Notice of Intent

Sundry ID: 2856743

Type of Action: APD Change

Procedure Description: WPX Energy Permian, LLC (aka Devon Energy Production Co., LP) respectfully requests a drill plan change for the subject wells (331H API ID 1400098053, 332H API ID 1400098054, 323H API ID 1400098051). WPX also requests break test and offline cementing variances. Please see revised drill plan for the deepest TVD well on this pad and variance attachments.

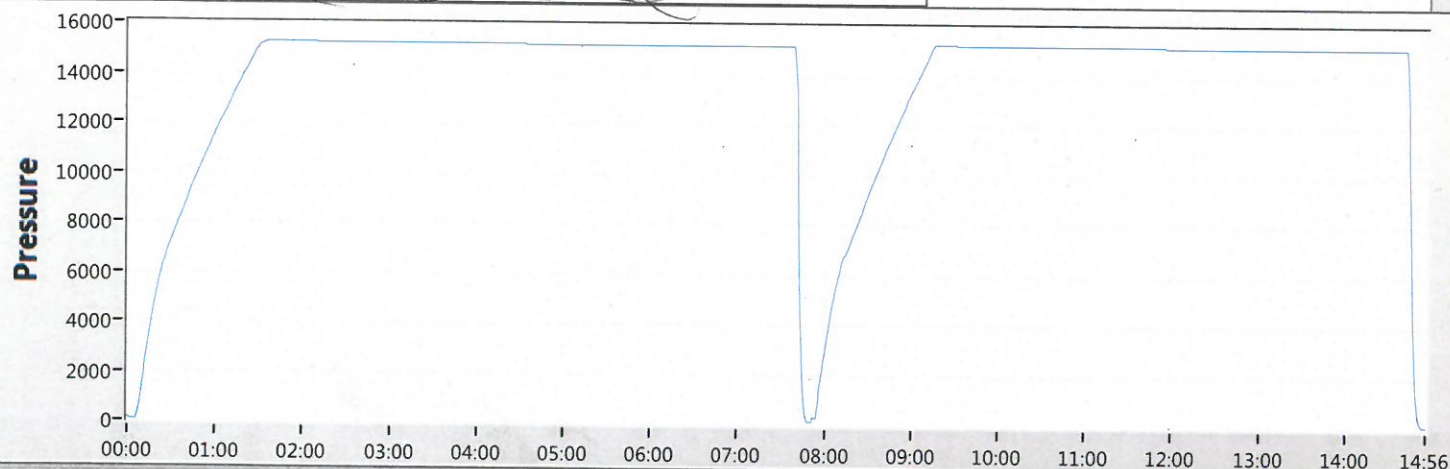
Devon requests Break testing as stated above for 5K tests, not including production hole

Annular Preventer will be tested to minimum of 70% RWP and higher than MASP during initial BOP test

Pressure testing is required for pressure-containing connections if the integrity of a pressure seal is broken during a break test

Full Tests required when entering production hole
